BID CLARIFICATION 1 FOR
REQUEST FOR PROPOSALS FOR
NEXUSPARK FIELDHOUSE DESIGN/BUILD

Columbus, Indiana

Issued: April 2, 2022

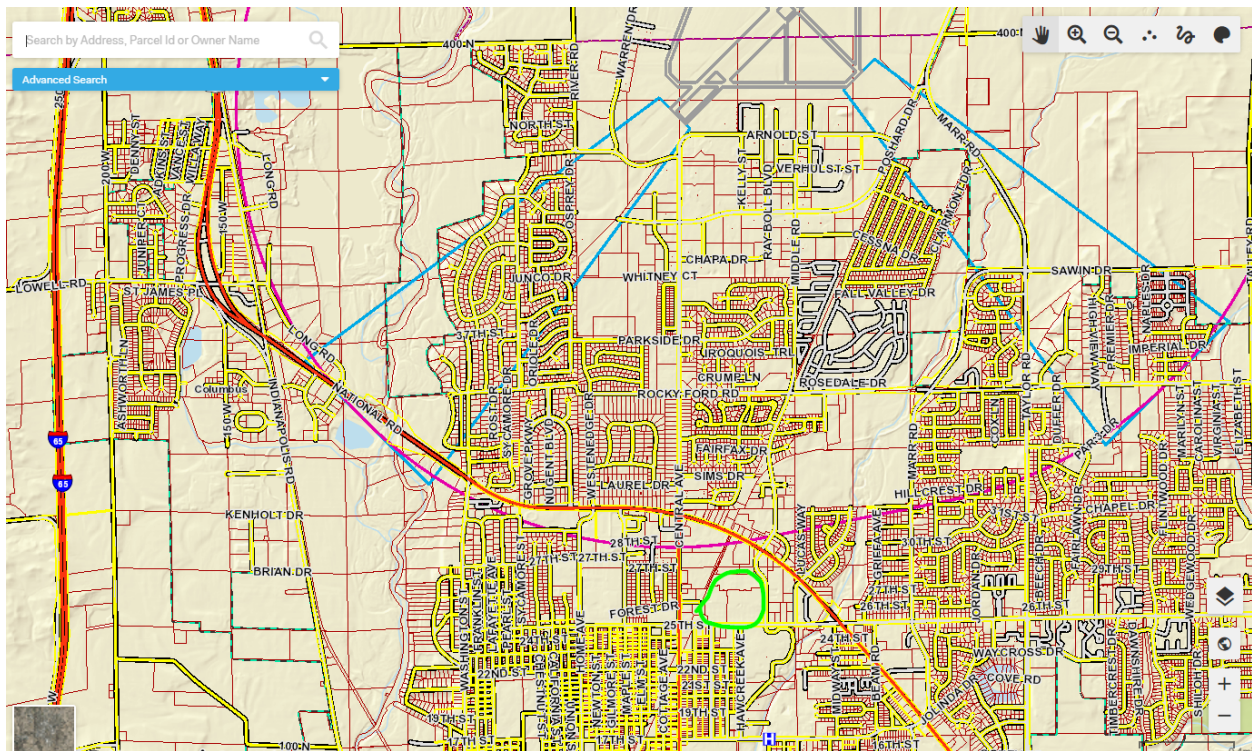
Question 5: With a proposed ridge height of 75', are there any height restrictions with the Columbus Airport only 2 miles away?

Answer: We are not aware of any direct discussion with the airport. However, the GIS data shows us outside of the 10,000 foot horizontal zone and approach zones. See snapshot below.
